NOTICE UNDER SECTION 96 OF ACT III OF 1901.

10th floor on plot No. 36 & 56

Survey Sheet No. A-12 situate in new

PLAN OF TOP FLOOR PROPOSED TO BE

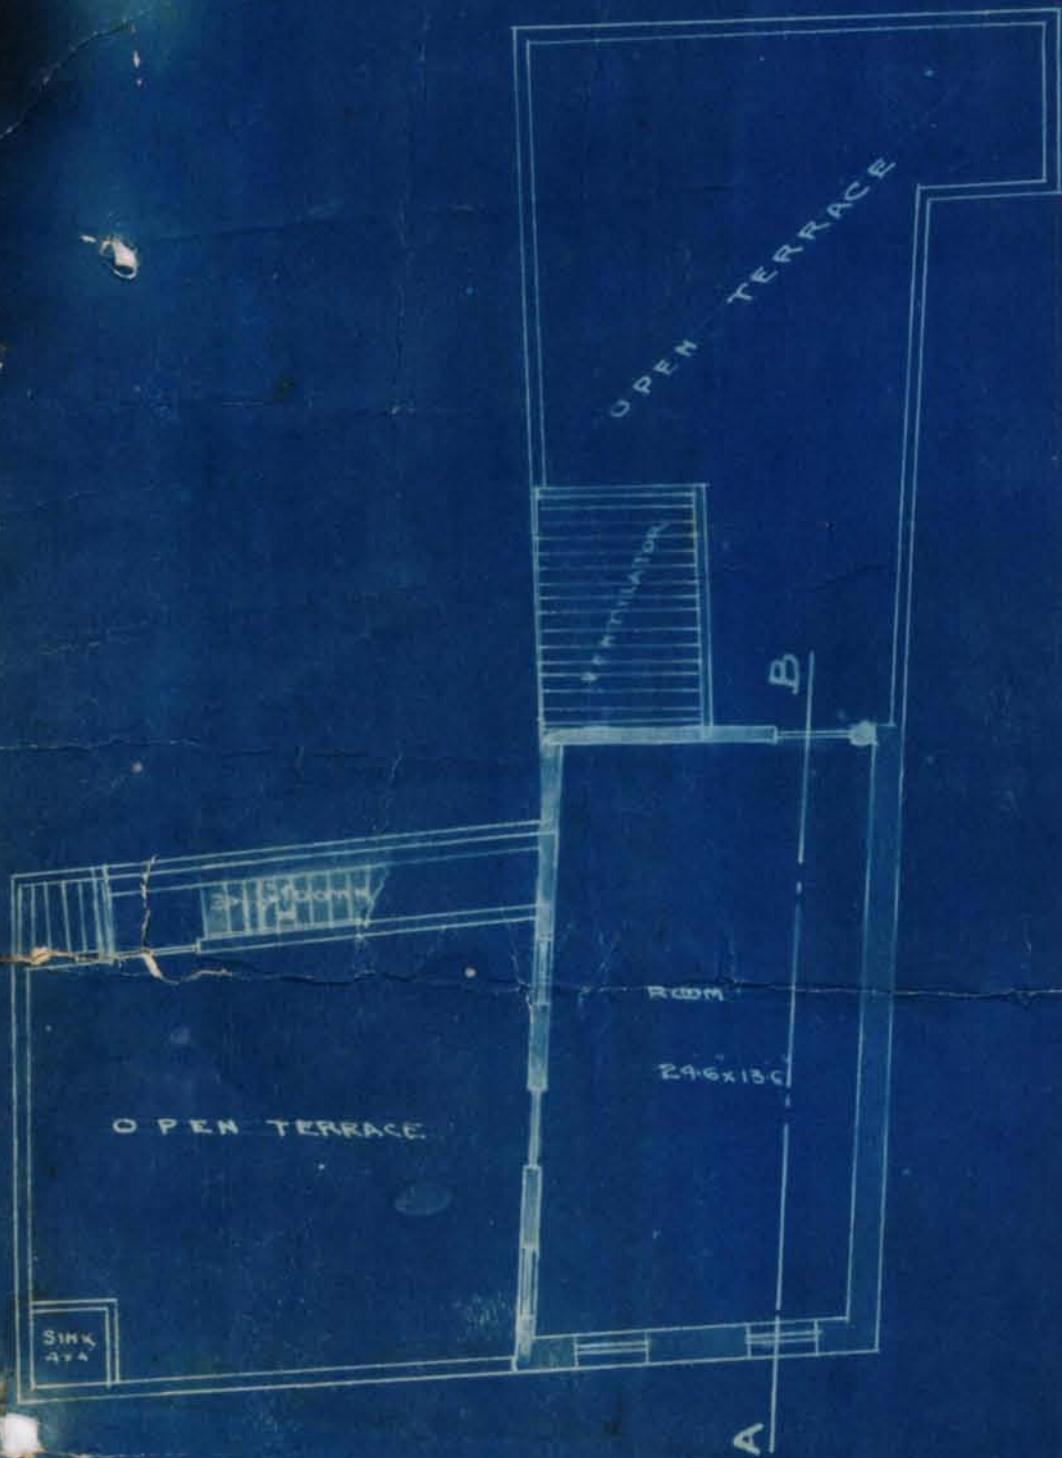
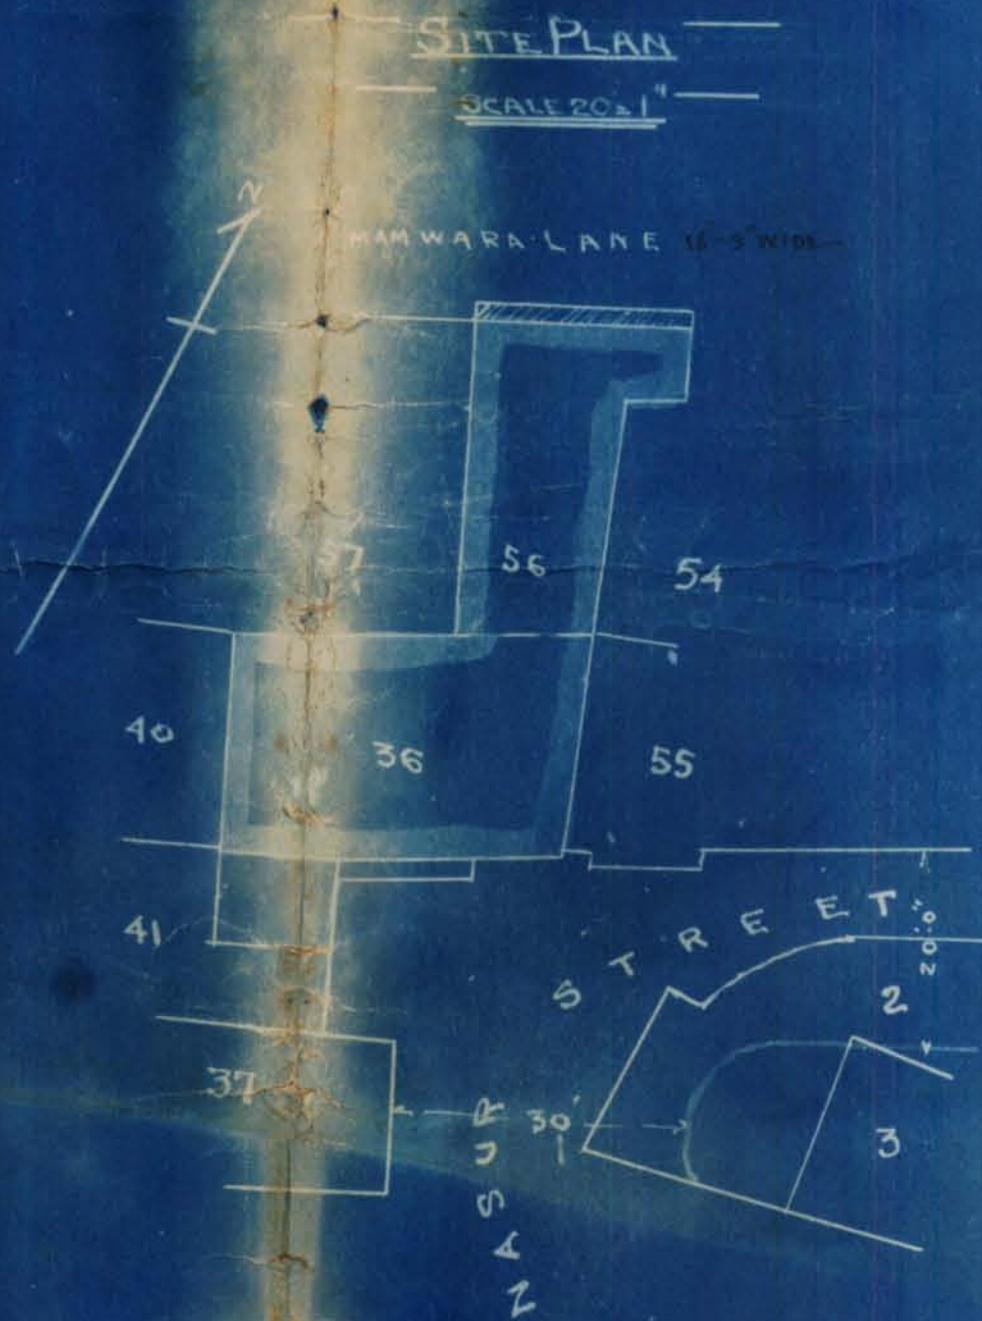
Remarks The plan is in complete the formation
of the present existing boundary must be shown
The chief officer has once refused permission
and is now bound to the work. Request you
order.

The existing walls on the first & 2nd floor are
kutcha & a third floor cannot be allowed
to be constructed over them. The proposed
room will block the light & air from the
existing open well.

With reference to his application dated 12th received on 19th November 1917 with plans for plot No. 36 & 56, A-12 Machi Meani Quarter Mr: Shahban Mohib is informed that the existing walls on the first and 2nd floor are katcha and a third floor can not be allowed to be constructed over them proposed room will block the light and air from the existing open wall. The plans are herewith returned for ~~amendment~~ ^{disapproved}.
